Our reference: LB-SFB2

15 September 2018

RE: PROPOSED GRANNY'S POOL TO MAIN BEACH BOARDWALK, ST FRANCIS BAY: COASTAL ENGINEERING REVIEW COMMENTS

Figure 1: Hazard level for the St Francis Bay area using the method used by CSIR for DEA Oceans and Coast¹

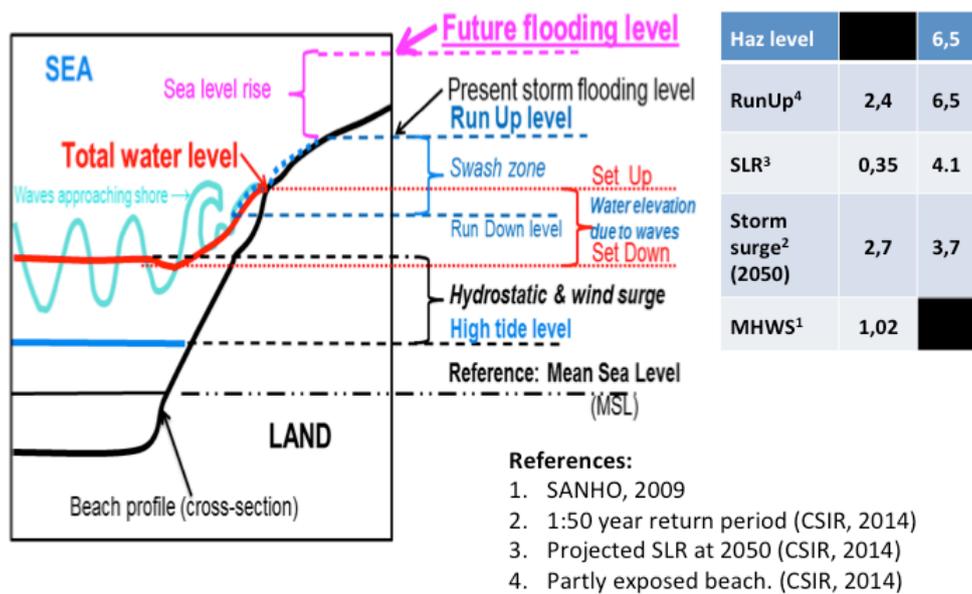
The parameters of importance in assessing the impact of the coastal processes on the walkway; and also the impact of the walkway on the natural processes are those numbered 11 to 15.

It can be seen that there is a likelihood that the walkway will have seastorm surges overwashing the lowest parts (elevation lower than +3.7 m MSL) even without any sea level rise (SLR).

It is a fact that the area at Granny's Pool is well protected from the prevailing seastorm waves. This will most probably limit the wave run-up factors so feature numbers 13 and 14 are probably highly conservative.

What can be concluded is that the lower portions of the walkway will be submerged by stormwaves on occasion and the risk of storm damage to the structure should be noted and accepted. This risk will be greater should the projected SLR be realized.
